Cirque Voltaire

Service Bulletin: SB 101

GAME: Cirque Voltaire (1st 200 samples)

SUBJECT: Disappearing Jet Bumper assembly not releasing.

Picture above shows the latch mounted incorrectly.

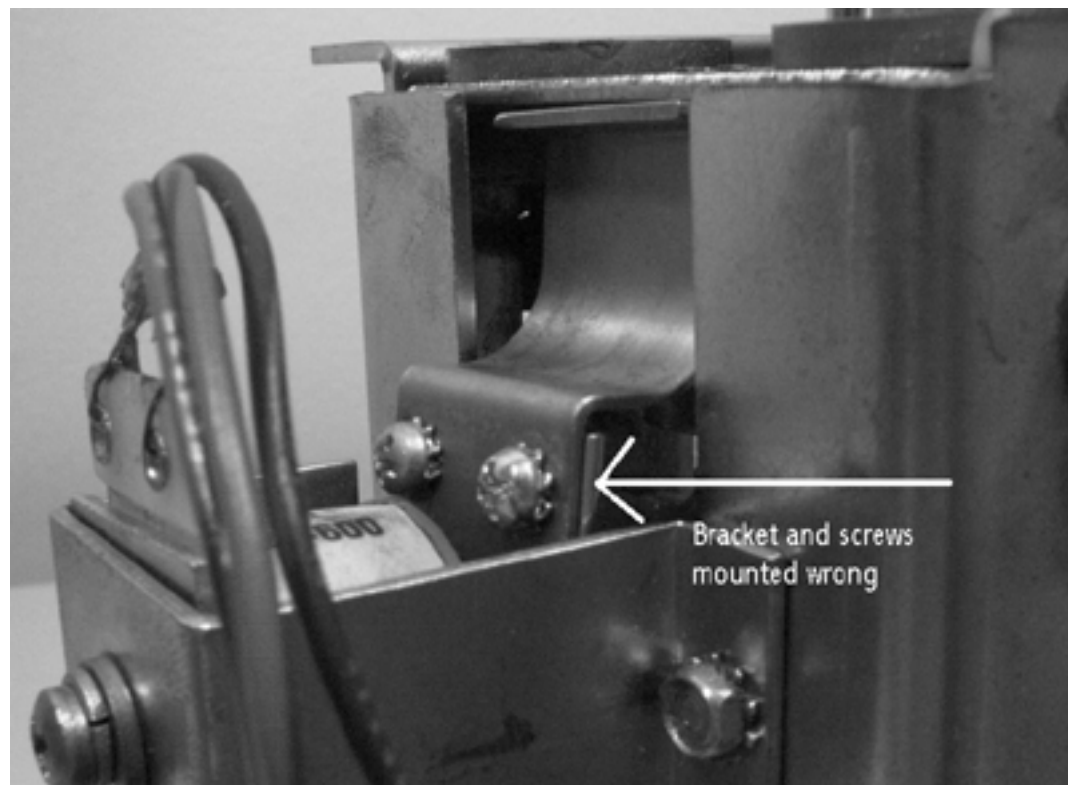
During our Quality Assurance testing we found that the brass latch which releases the disappearing jet bumper was installed incorrectly. Quality also found that the release coil frame was bending down. Both of these problems can affect the reliability of the jet bumper to drop. The 2 pictures below show the right and wrong way that the latch should be mounted. The bottom picture shows the bracket (Part #01-14803) that has been added to prevent the coil frame from bending.
